ADDENDUM NO. 1

**HANOVER COMMUNITY SCHOOL CORPORATION - NEW RESOURCE
CENTER AND RELATED WORK
Cedar Lake, IN 46303**

This Addendum consists of page ADD 1-1 and attached Addendum No. 1 from Gibraltar Design dated May 27, 2021 and consisting of 5 pages and 48 drawings.

DRAWING
ROOF PLANS

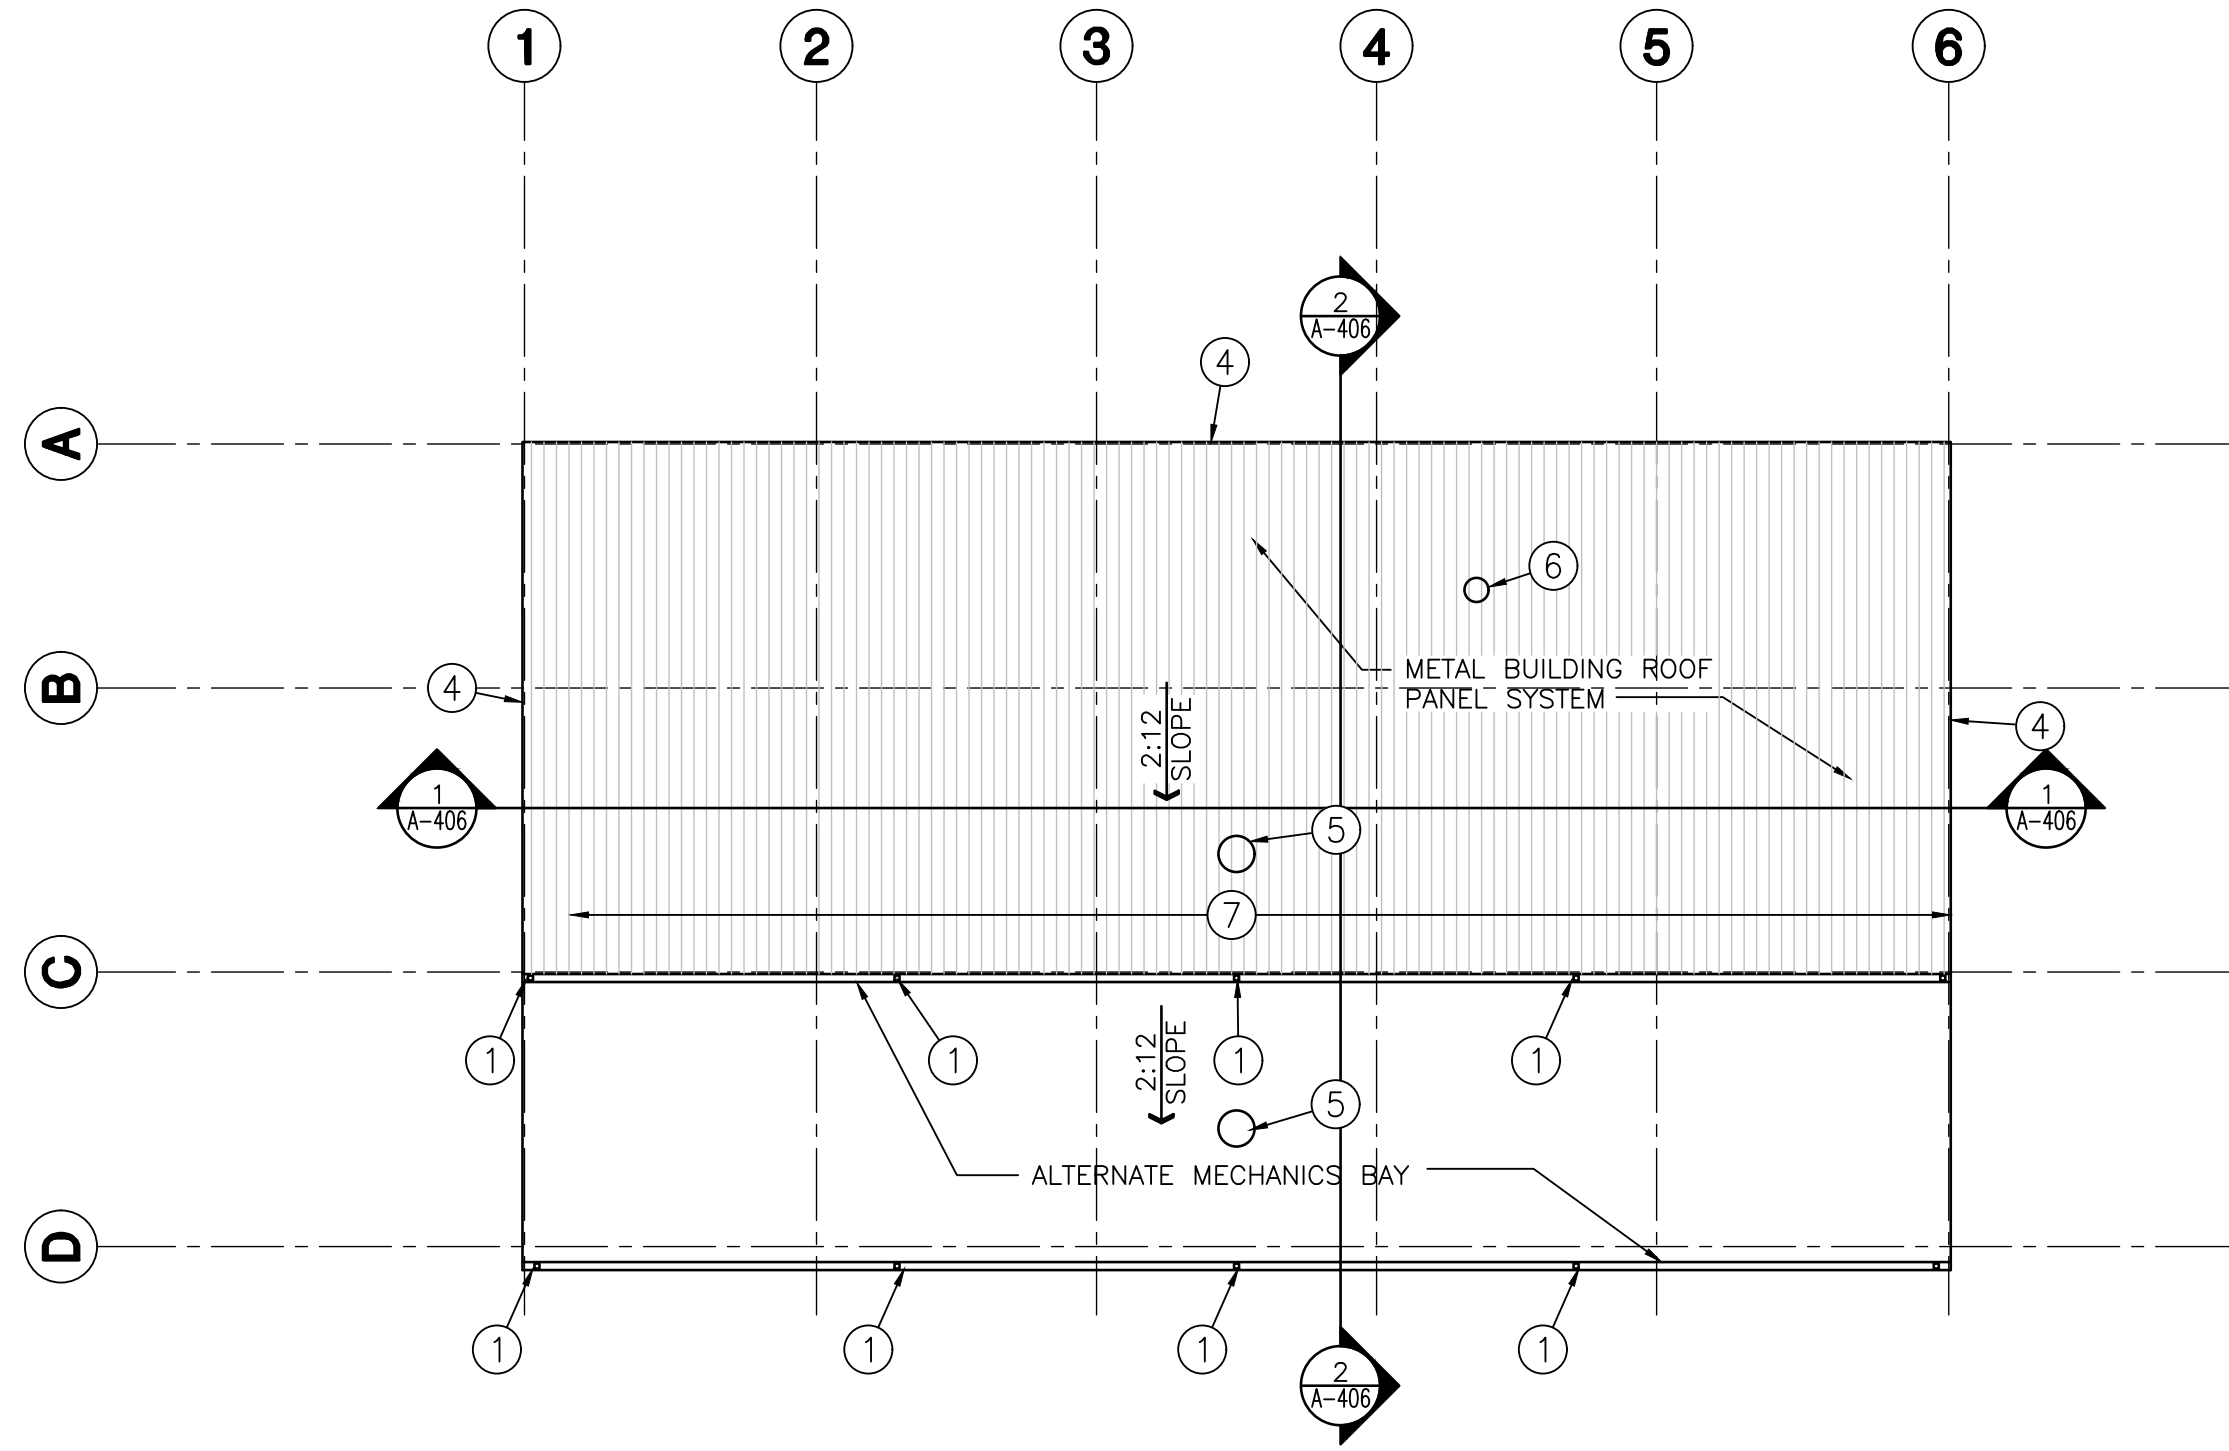
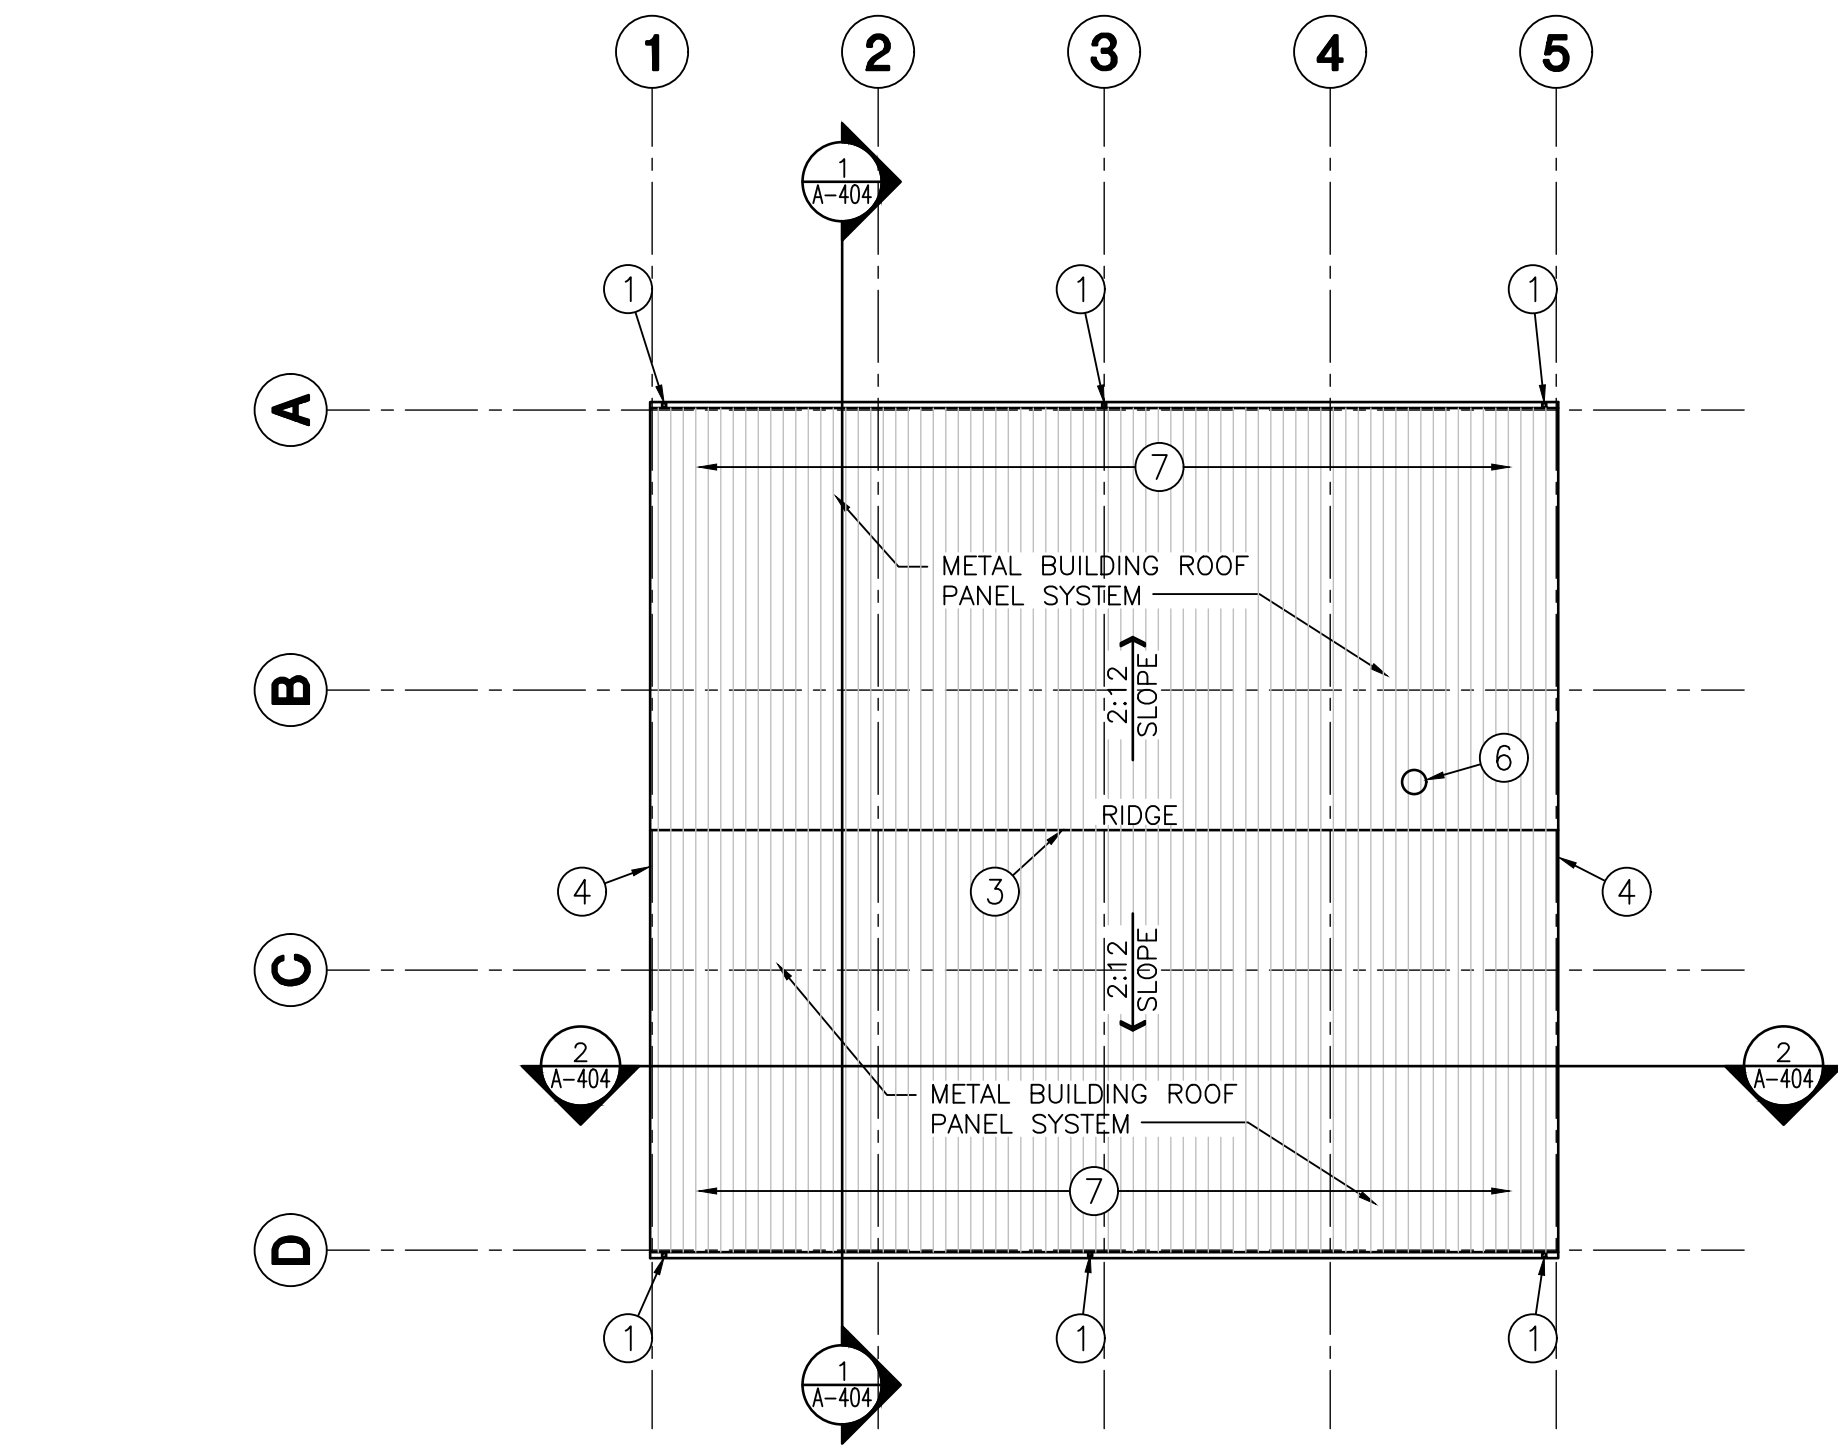
14. Sheet A-201 and A-301

- A. Refer to two (2) Full Size Drawing Sheets included in this Addendum for revisions.
